SERVICE KIT NO. SK-114

DATE: March 29, 1972  
~~TIME:~~  
 SUBJECT: Front Seat Improvements  
 SERIALS AFFECTED: AA5-0001 thru AA5-0089  
 WEIGHT AND BALANCE CHANGE: Negligible

Description of Modification

This modification incorporates recent production improvements which make the front seat latching more pronounced and positive and strengthens the seat support attachment.

FIGURE 1.

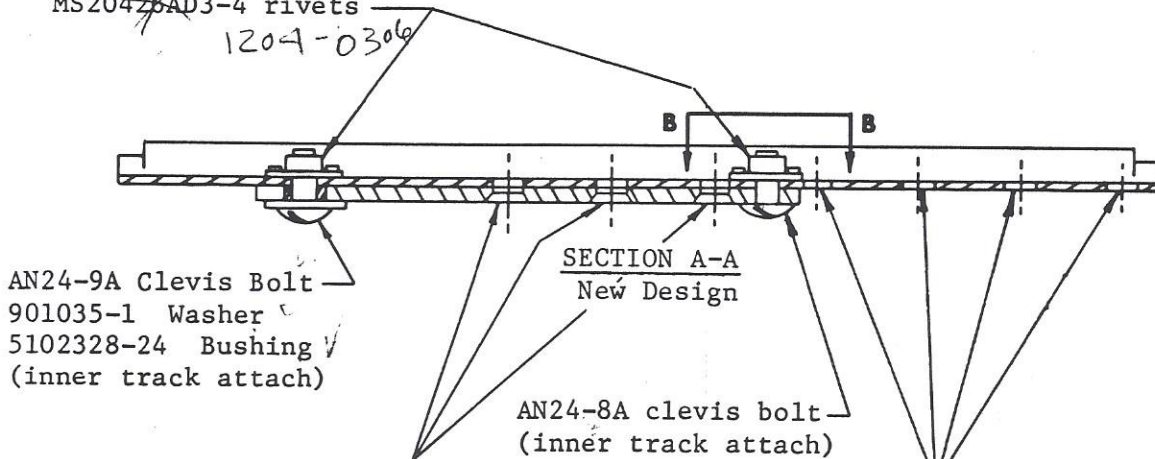
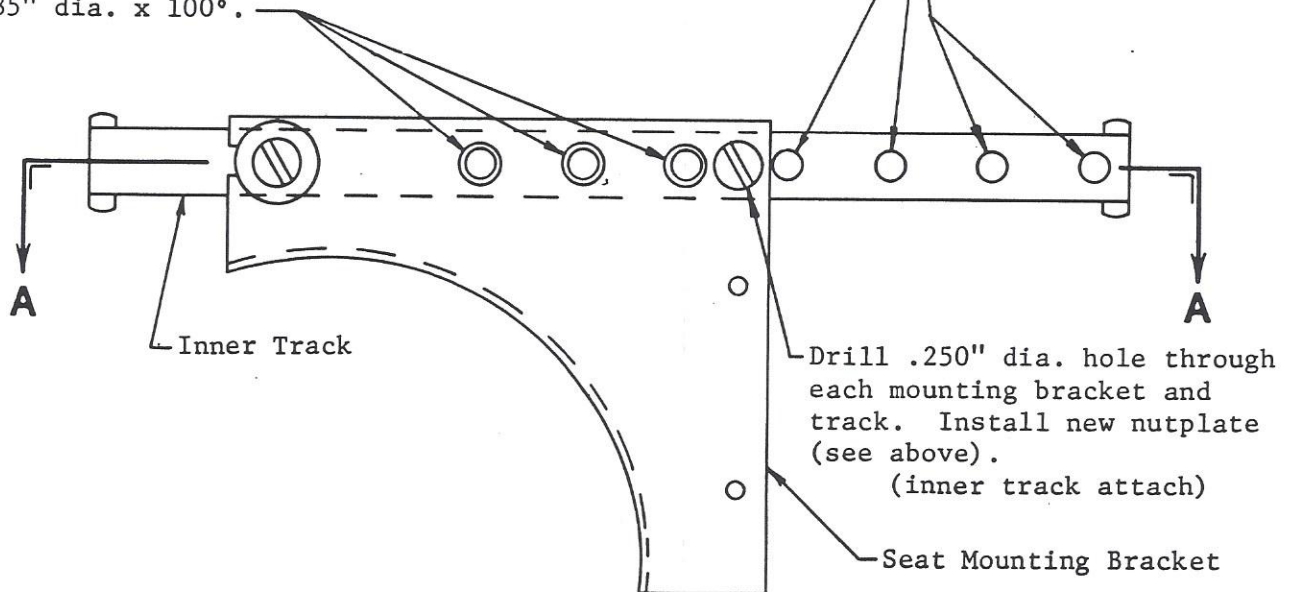
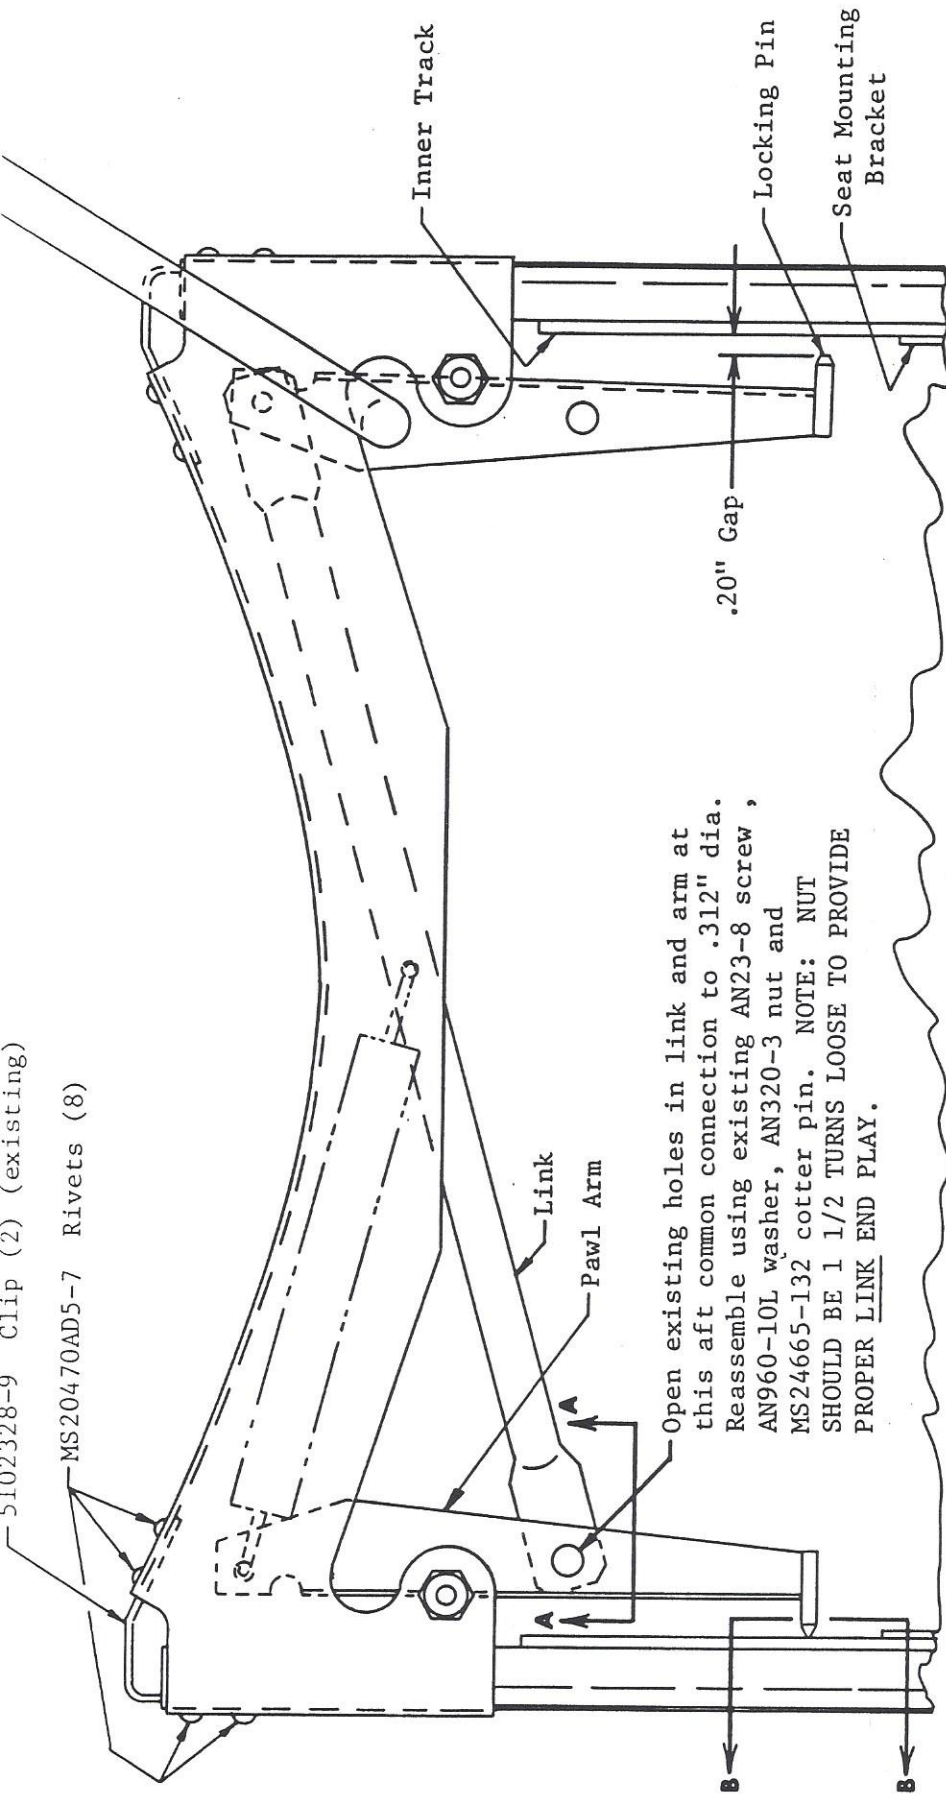
4. Modify the inner tracks by enlarging the .203" dia. lock pin holes to .312" dia. (7 holes per track) (Note: this already incorporated on aircraft serial no. AA5-0064 and up). Remove (and discard) the clinch nuts, drill out holes to .250 dia. and install NAS697A4 nut plates and MS20426AD3-4 rivets supplied with kit. (See Fig. 1)

10. Cycle seat adjustment mechanism to confirm full engagement and release of the locking pins at the full forward and full aft track positions.
11. On the seat mounting brackets (still mounted to center spar in the aircraft), drill the existing .203" dia., (3) lock pin holes to a .312" dia. and countersink .385" dia. x 100° on the inside surface (to each seat), of each bracket. (Note: this already incorporated on serial no. AA5-0058 and up). This helps guide the lock pins in place. Drill the existing forward seat rail attach bolt hole in each bracket to .250" dia. (Fig. 1)

Install NAS697A4 nutplates with  
MS20426AD3-4 rivets

Drill .312" dia. through mounting  
brackets and inner track. Counter-  
sink 3 holes in each bracket to  
.385" dia. x 100°.

Enlarge ALL lock pin  
holes to .312" dia. in  
inner track.

FIGURE 2.

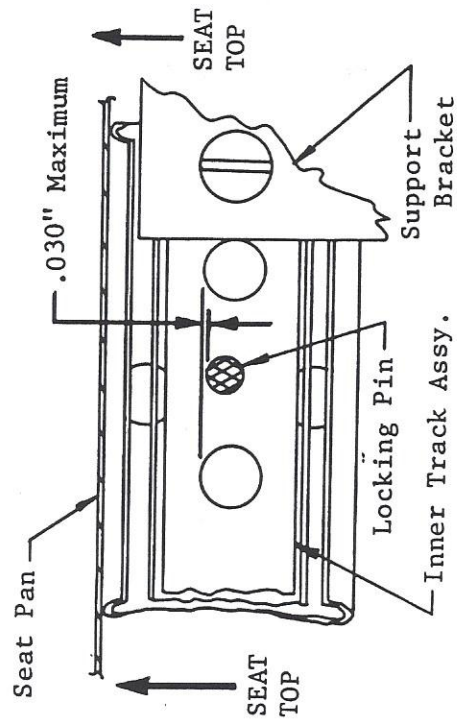
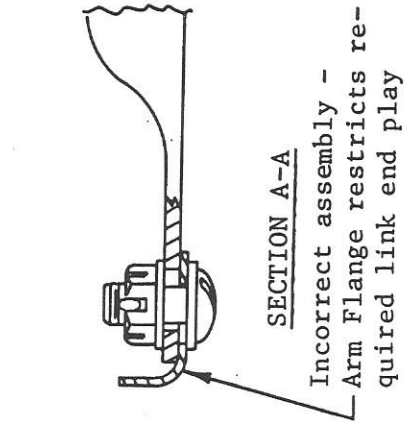
5. Install the new 5102328-24 bushings, 901035-1 washer and AN24-9A clevis bolts, from the Service Kit, at the aft track mounting holes.
6. Open up hole in link and pawl arm (aft common connection) to .312" dia. and reassemble connection using original hardware (See Figure 2). Be sure the link is installed on the side opposite the pawl arm flange as shown in Figure 2, Section AA. Nut should be 1 1/2 turns loose to provide proper link end play.

8. Bend both pawl arms up toward seat pan so that top of pin is aligned with top of adjustment holes within .030" as shown in Fig.2 Sec. BB.
9. To confirm proper linkage operation, place a .20" thick spacer between inner track and locking pin on one side while checking that the opposite side pin is positively spring loaded against its track. Reverse this procedure to check operation on the other side. Elongate new hole in link for any required adjustment (Fig. 2).

Open existing holes in link and arm at this aft common connection to .312" dia. Reassemble using existing AN23-8 screw, AN960-10L washer, AN320-3 nut and MS24665-132 cotter pin. NOTE: NUT SHOULD BE 1 1/2 TURNS LOOSE TO PROVIDE PROPER LINK END PLAY.

SECTION B-B. LATCH PIN ADJUSTMENT  
(View rotated 90° counterclockwise)

SECTION A-A  
Correct assembly - Link mounted on side opposite arm flange allows maximum end play required for proper latching operation. ELONGATE NEW .312 DIA. HOLE IN LINK IF ADDITIONAL END PL. IS REQUIRED PER PAR. 9.  
Incorrect assembly - Arm Flange restricts required link end play
